161<sup>st</sup> session

### **Proposal for the 05 series of amendments to Regulation No. 10 (Electromagnetic compatibility)**

**Submitted by the Working Party on Light and Lighting-signalling\***

Figure 1  
HV artificial network

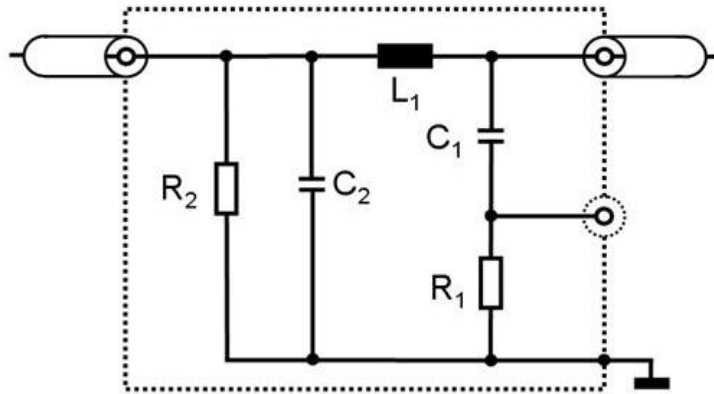
## "Appendix 8

### HV artificial network

<i>Legend</i>	$C_2: 0.1 \mu F$
$L_1: 5 \mu H$	$R_1: 1 k\Omega$
$C_1: 0.1 \mu F$	$R_2: 1 M\Omega$ (discharging $C_2$ to $< 50 V_{dc}$ within 60 s)

Figure 1  
**Vehicle in configuration "REESS charging mode coupled to the power grid" – Single phase charger test set-up**

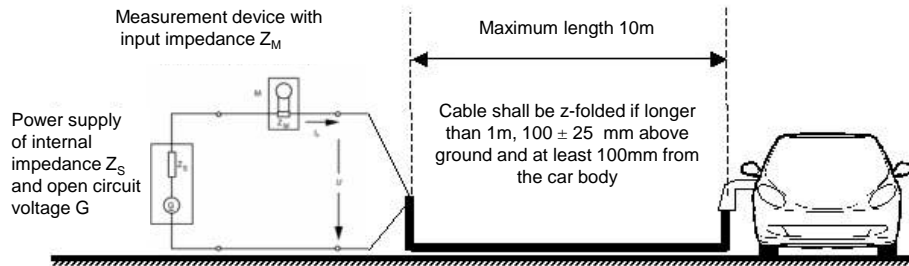
**"Annex 11 – Appendix**

Figure 1a

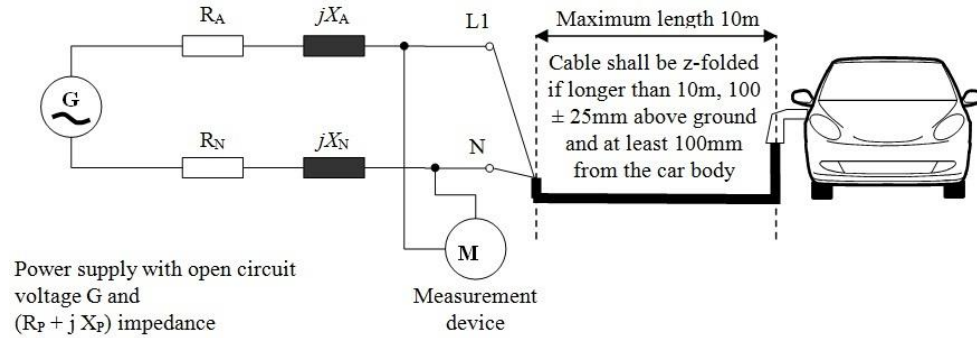
*Annex 12, amend to read:*

Figure 1  
Vehicle in configuration "REESS charging mode" coupled to the power grid coupling on AC/DC power lines

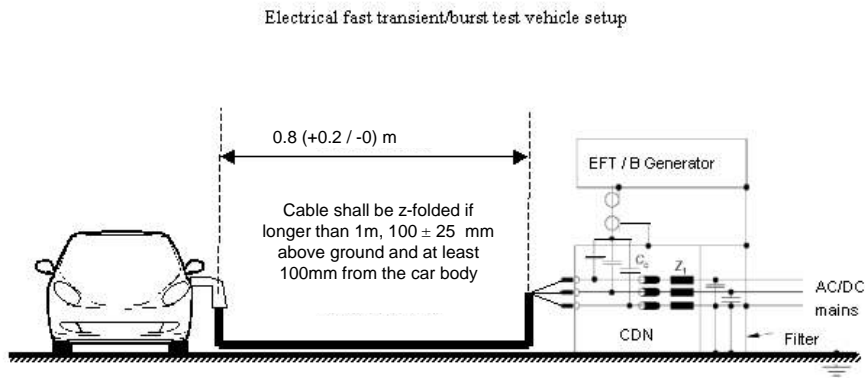
Annex 15, Appendix, amend to read:
